# PRODUCT CHANGE NOTIFICATION

| PCN No.: PCN-202608-031                                     | PCN Doc No.: EC-20260826-PCN-01        | Date Issued: 2026/8/26                |
| Part Number or Series: SCC-Q1-06-G-SMT-T/R                  |                                        | PCN Effective Date: 2026/8/26         |

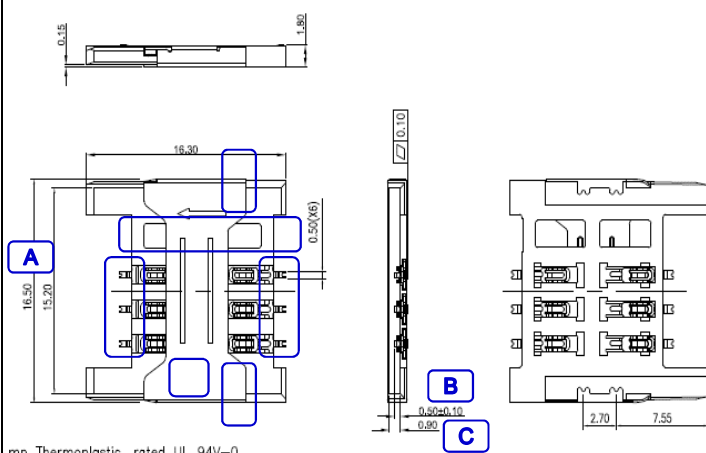
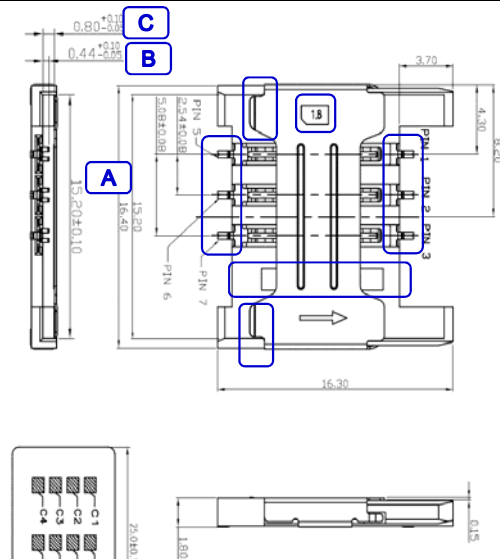
**Change Description:** Manufacturing new molds to replace and optimize structures;

**Impact of Change:** Same function, slightly different appearance and size;

- 1、Appearance ~ As shown in the above picture;
- 2、Size:
  - A) 16.50mm    B) 0.50mm    C) 0.90mm

- 1、Appearance ~ As shown in the above picture;
- 2、Size:
  - A) 16.40mm    B) 0.44mm    C) 0.80mm
